**LITTLEBOURNE INVESTEMENTS
LIMITED**

SERVICE OF NOTICE / LIMITED NOTIFICATION

To remove an existing swing mooring from the bed of Lake Wakatipu (Whakātipu-Wai-Māori), and to re-establish it in a new location, requiring land use consents from the Otago Regional Council and the Queenstown Lakes District Council.

**NOTIFICATION ASSESSMENT UNDER s95A AND s95B OF THE RESOURCE
MANAGEMENT ACT 1991 (RMA)**

Figure 1: Location of existing swing mooring M54 (large orange dot), compared to proposed location (as indicated), in relation to surrounding moorings and features.

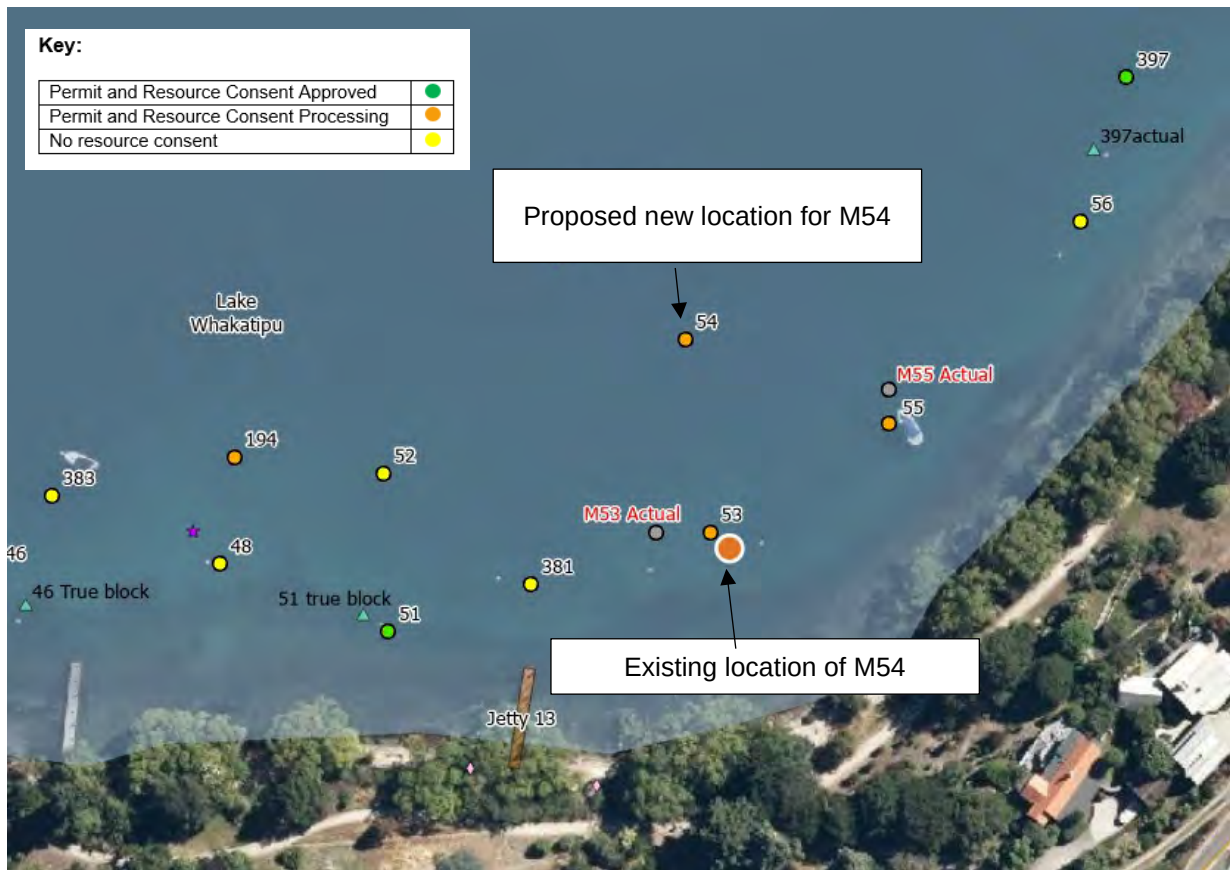
During the processing of this application, the QLDC Harbourmaster raised navigational safety concerns regarding the existing location of M54. The Applicant has subsequently confirmed² that the new proposal is to relocate the existing swing mooring system approximately 35m to the north of its existing location in order to avoid a swing radius conflict (detailed further in Section 3.3.3 below). The proposed GPS coordinates for the mooring are now as follows, as shown in Figure 1:

Based on a total swing radius of 16 metres (including 9m vessel), the QLDC Harbourmaster initially identified that there was a swing radius conflict with adjacent mooring M53 (resource consent application is currently being processed), the location of which are shown in Figure 1 above. Before the QLDC Harbourmaster could support the application, he advised that these swing radius conflicts would need to be addressed (and removed), and the existing mooring block which was identified as being comprised of three concrete tubes would need to be upgraded to meet the requirements of the Guidelines contained within the QLDC Mooring Booklet.

To address the Harbourmaster’s concerns, the Applicant volunteered to upgrade the mooring system and shift the mooring to the location shown in Figure 1 above, which will avoid any swing radius conflict with surrounding moorings. Accordingly, it is accepted that the amended mooring position is suitable (subject to confirmation by a diver prior to placement). The mooring will be marked with a buoy to make it clearly visible, and its location will not impede any craft manoeuvring in this area.

MOORING LOCATION DIAGRAM – M54

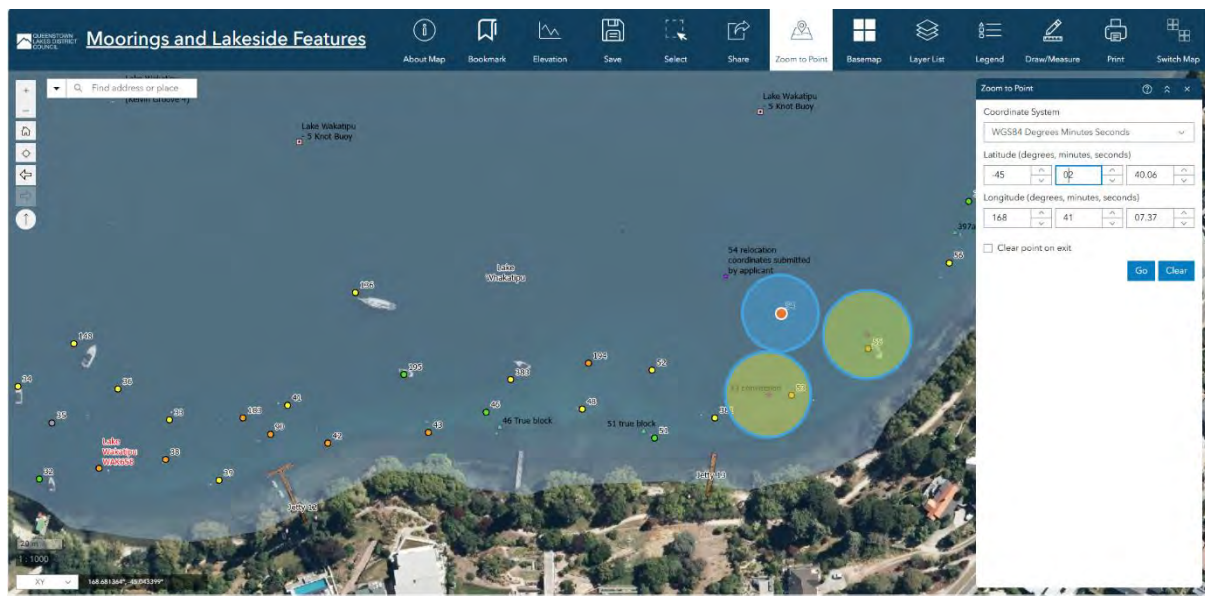
Safety Management comments	A Resource Consent application in regard to the mooring M54 was filed with the Queenstown Lakes District Council on 17.05.2026. As part of this process, the applicant submits a mooring survey document from a recent mooring inspection carried out on the mooring to show it is fit for purpose and meets the requirements under the Navigational Safety Bylaw 2025, after having the applicant supplied mooring survey document forwarded to myself for a desktop review and comment. Mooring Swing Radius Using the coordinates supplied by Garry Wright within the mooring survey document, I note that there is a swing radius conflict with surrounding mooring M53, when considering the swing radius made up of mooring swing radius of 7.0 metres and a vessel length of up to 9.0 metres totalling 16.0 metres. Applicant mooring relocation The applicant has agreed to relocate their mooring further out into Lake Wakatipu to avoid conflict with surrounding moorings, taking surrounding mooring positions into consideration I would recommend the above position for the mooring M54 to be re-established, this location and lakebed suitability will need to be confirmed suitable by a diver before relocation can take place. Mooring Block Noting I also note that the mooring block is shown as 3x concrete tubes with a combined weight of 300kg. This mooring will need to be upgraded to meet the requirements of the QLD Mooring guidelines. Due to the conflict with the above surrounding moorings, I am unable to support this application at this time until the conflict has been addressed, or a plan put forward to show there would no longer be a conflict present.
